SERVICE BULLETIN NZ SB121

Units affected: ALL SR2770's built between Aug 2001 and Aug 2002

Installation procedure for replacement Drive valves.

This picture shows which valves on the manifold need to be changed.

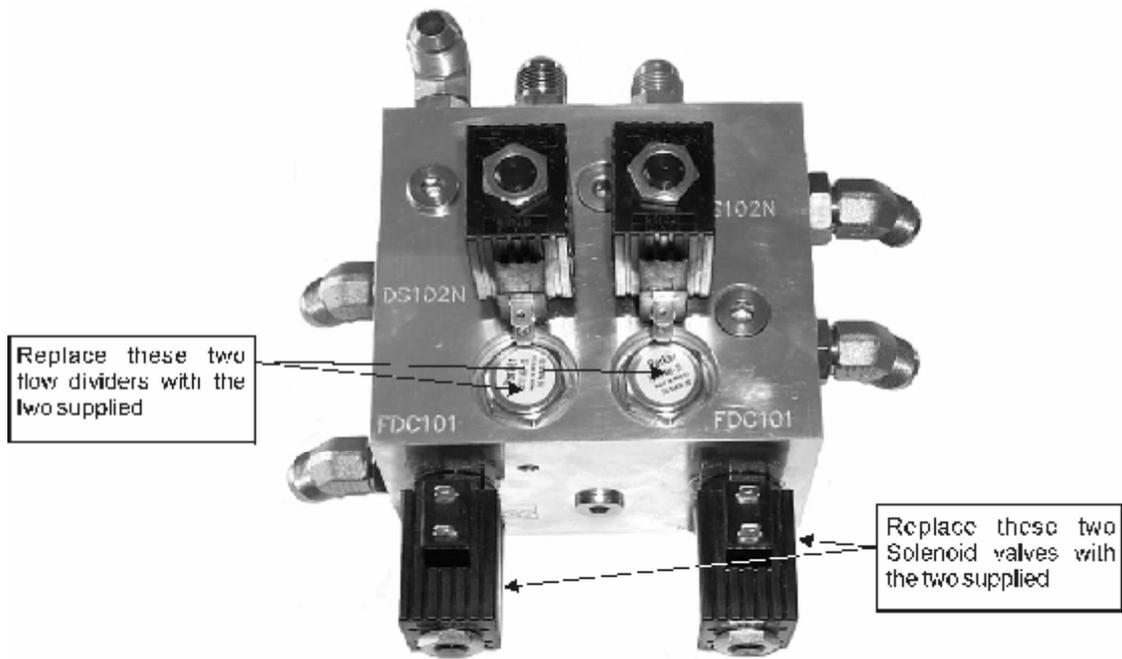
The change consists of replacing two Flow Divider/Combiners and two Solenoid valves.

- **Park the machine on firm level ground. Raise the scissor and put the safety prop in place. Place a suitable drip tray under the rear axle to catch any oil split.**
- **Remove the sheet metal cover at the rear of the machine to gain access to the Drive Manifold.**
- **Remove the valves as shown [refer to the picture attached] and replace with the valves supplied.**

To minimize the amount of oil spilt, replace one valve at a time.

The coils must remain attached to the solenoid valve whilst these valves are installed as it is not possible to fit the coils once the valve is in place.

Do not over-tighten the valves, the correct torque setting is 22N.m [180In/lbs].
